RE: **Juan Tabo Hills Park**
Grading and Drainage Plan for GP, SO-19, and BP- Approved
Engineer's Stamp Date: 12/5/2018 (M22D017A)

RE: JUAN TABO HILLS PARK (M22D017A)

Attached with this resubmittal are copies of a revised Grading and Drainage Plan and Supplemental Calculations to address your review comments dated September 18, 2018. Please see below for our responses to your comments.

RE: **Juan Tabo Hills Park**
Grading and Drainage Plan for SPBP – Approved
Engineer's Stamp Date: 9/12/2018 (M22D017A)

JUAN TABO HILLS PARK SUMP INLET WEIR CALCULATIONS

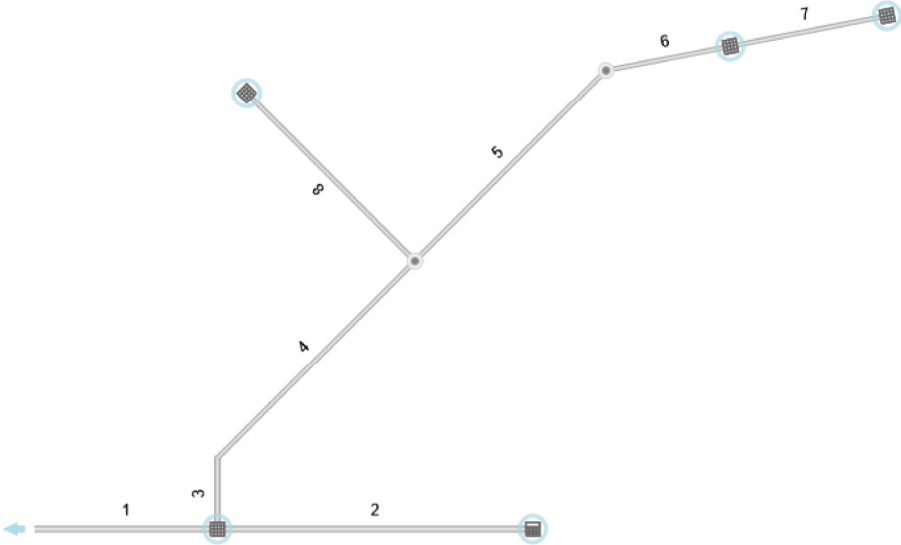
1. Remove the label "Not for Construction" under the engineer's stamp and sign the stamp.
2. Verify the Sidewalk Culver Capacity using the weir equation. Grates are now standardized at 24". Use the appropriate number of grates.
3. Add a construction note on the plan stating that an excavation and barricading permit is required for the New Type D inlet on the existing public storm drain and the Sidewalk Culverts.
4. Verify the Gulfstream Ct. inlet calculations using a weir equation at the lip of gutter, which is 0.75' below the property line elevation.
5. Grant Public Drainage easements on the existing 48"- 66" storm drain on the east side of the site (25' min width centered on the pipe) both north and south of Monachos Rd.

Q	flow (cfs)	
Cw	weir coefficient	3.33
P	perimeter (ft)	10.83
h	height of water (ft)	0.75

$$Q_w = C_w * P * h^{3/2}$$

Q = 23.4 cfs

Qreq= 25.0 cfs

1.6 cfs will bypass to sump inlet downstream

1. Plans are stamped and signed.
2. Calculations for sidewalk culvert capacity using weir equation are attached. Four 24-inch sidewalk culverts are required.
3. The construction note has been added.
4. Calculations for inlet capacity using the weir equation are attached. Per these calculations, 1.6 cfs will overflow to the downstream sump inlet. There is a wall along the cul-de-sac adjacent to the west property, so no flows will enter the offsite property. Revised storm drain calculations to reflect added flows at the sump inlet are attached.
5. The public storm drain easement is in the process of being prepared by the Parks Department surveyor.
